Access Compliance Report

Public Rights-of-Way

(Curb Ramps)

Intersection ID: 46917	Main Street: RAISIN_TREE_LN	Cross Street: MONARCH_BIRCH_LN	Location: SW
ADA ID: 82C127821A1B	Ramp Type: PerpDiag	Initial Pass/Fail: Fail	Overall Compliance: No
Severity Score: 21.25			
Codes/Mitigation Info/Possible Solution		Field Measurements/Component Compliance

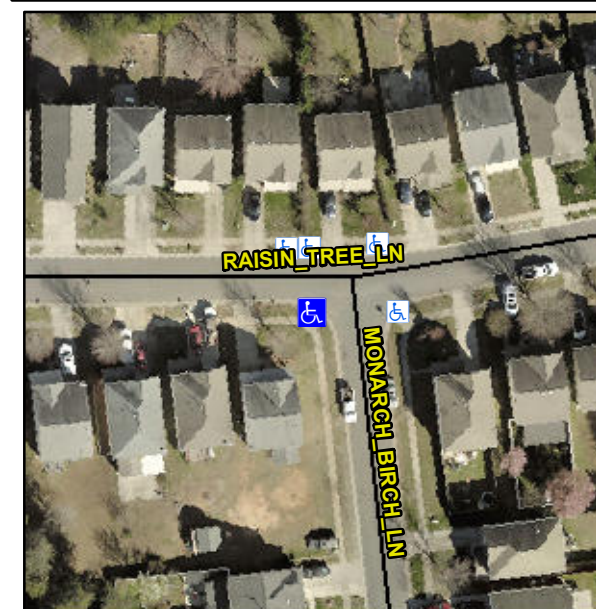
R304.5.1, R304.2.2

Compliance	Description	Data	Compliance	Description	Data
N/A	Ramp Length (in)	78.0	No	Ramp Slope (%)	8.6
No	Ramp Width (in)	46.5	Yes	Ramp XSlope (%)	0.3
N/A	Flare Type LT	N/A	N/A	Flare Type RT	N/A
N/A	Flare Slope LT (%)	N/A	N/A	Flare Slope RT (%)	N/A
N/A	Flare Traversable LT?	N/A	N/A	Flare Traversable RT?	N/A
N/A	Landing Length (in)	N/A	N/A	DWS Provided?	N/A
N/A	Landing Width (in)	N/A	N/A	DWS Contrast?	N/A
N/A	Landing Slope (%)	N/A	N/A	DWS Length (in)	N/A
N/A	Landing X Slope (%)	N/A	N/A	DWS Full Width?	N/A
N/A	Landing Curb? (Y/N)	N/A	N/A	DWS Offset (in)	N/A
N/A	Shared Landing?	N/A			
N/A	Gutter Ponding?	N/A	N/A	Gutter Slope (%)	N/A
N/A	Gutter Lip Ht (in)	1.0	N/A	Gutter X Slope (%)	N/A
N/A	Painted X Walk1?	No	N/A	Painted X Walk2?	No
	X Walk 1 Direction	To E		X Walk 2 Direction	To N
N/A	X Walk 1 Width (in)	N/A	N/A	X Walk 2 Width (in)	N/A
	X Walk 1 Slope (%)	0.0		X Walk 2 Slope (%)	1.0
	X Walk 1 X Slope (%)	0.2		X Walk 2 X Slope (%)	3.0

Remove & Replace Curb Ramp With Two New Directional Ramps or Equivalent.
